## PLAT COMMITTEE

<b>Case Number:</b>	2023-PLT-089
<b>Property Address:</b>	5202 & 5240 Pike Plaza Road ( <i>Approximate Address</i> )
<b>Location:</b>	Pike Township, Council District # 10
<b>Petitioner:</b>	Kesler Limited Partnership, by Paul J. Lambie
<b>Zoning:</b>	C-5 (FF) (FW)
<b>Request:</b>	Approval of a Subdivision Plat, to be known as Kesler Plat, dividing 7.55 acres into two lots, with a waiver of the sidewalk requirement along Pike Plaza Road and Lafayette Boulevard.
<b>Waiver Requested:</b>	waiver of the sidewalk requirement along Pike Plaza Road and Lafayette Boulevard
<b>Current Land Use:</b>	Undeveloped / Parking
<b>Staff Reviewer:</b>	Allison Richardson, Senior Planner

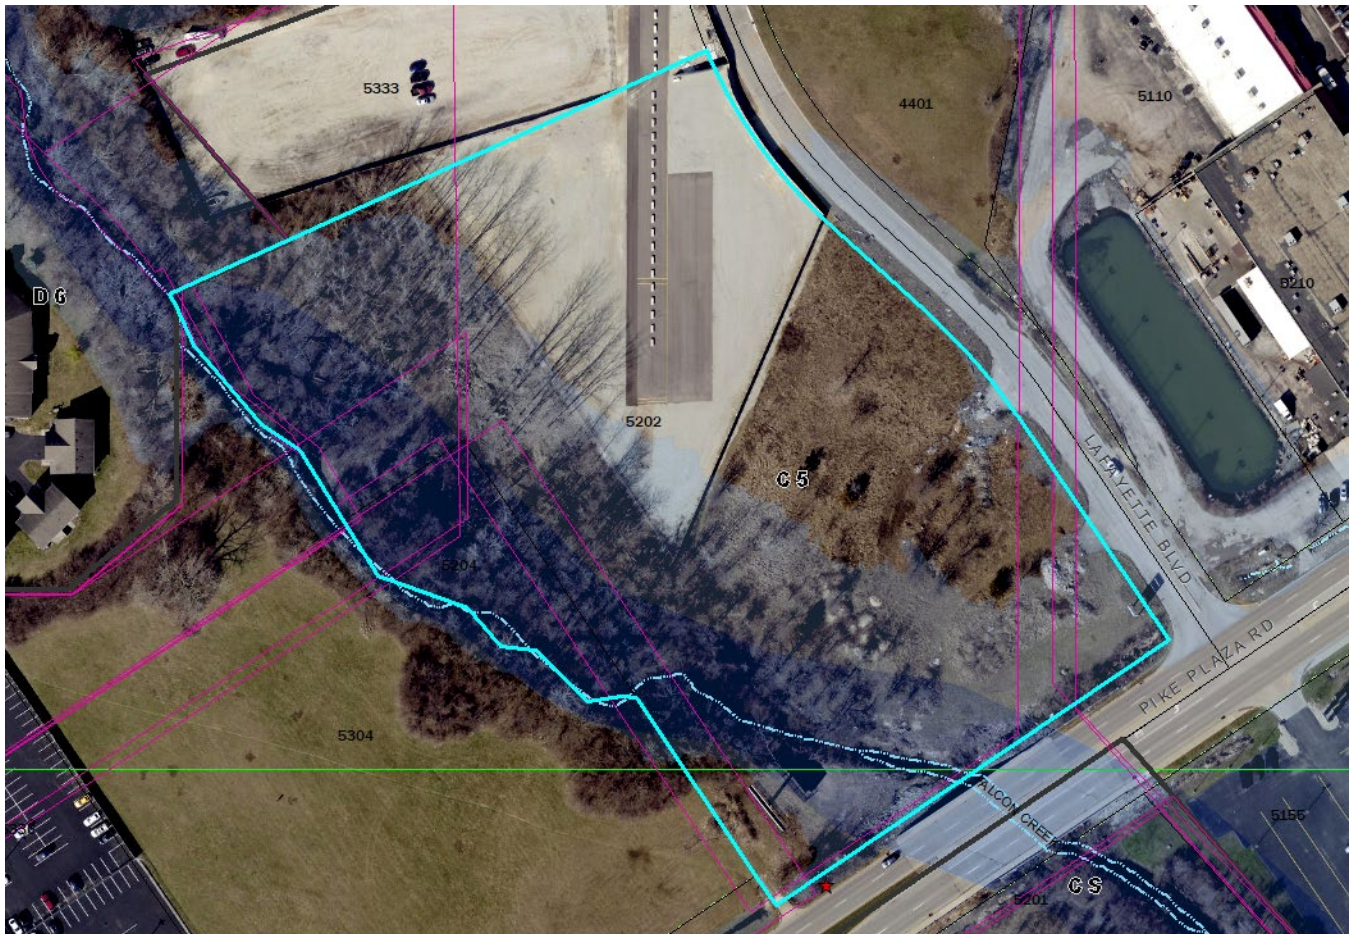
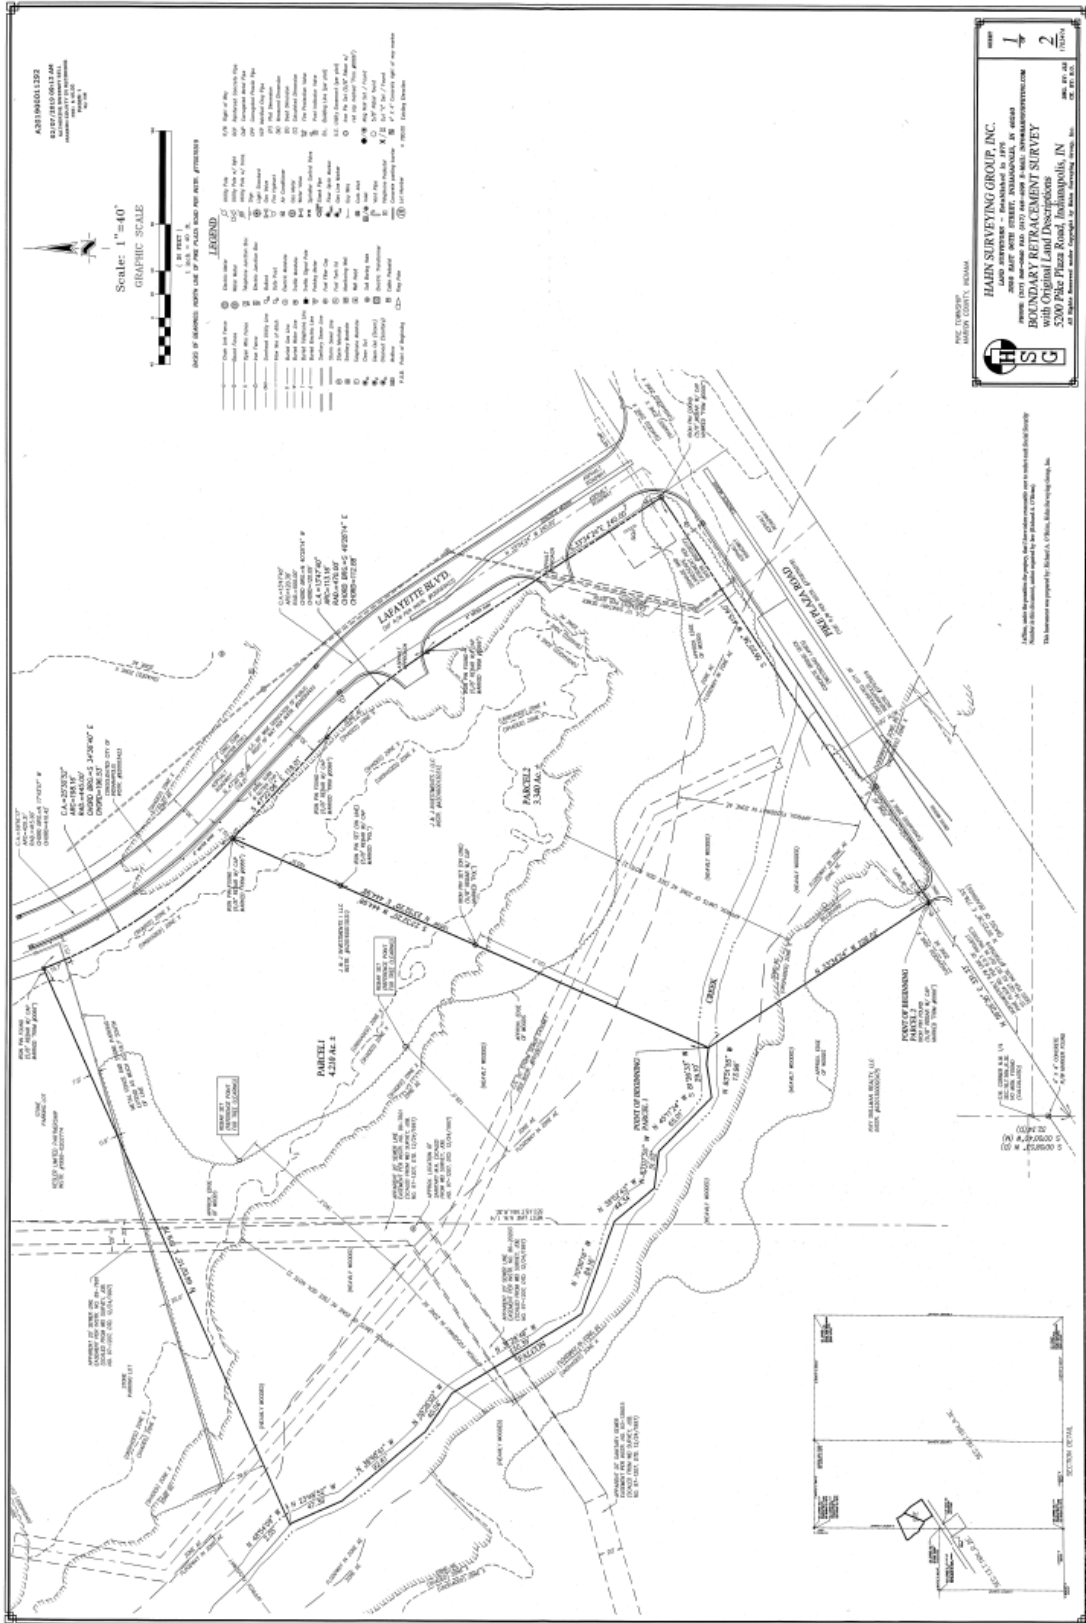
Sidewalks would be required to be installed along Pike Plaza Road and Lafayette Boulevard per the ordinance. There is a drainage ditch along Pike Plaza Road; however, there is a bridge including a sidewalk over Falcon Creek on the south frontage, which would suggest that installation of sidewalks is possible. There is also evidence of people walking on this frontage per the Google Street View image below, indicating that pedestrian infrastructure is needed. There are no topographic challenges for installing sidewalks along Lafayette Boulevard. Therefore, staff is recommending denial of the waiver.

If the plat committee approves the waiver against staff's recommendation, a contribution in lieu of sidewalk installation should be required as a condition of approval subject to Section 744-301.G.
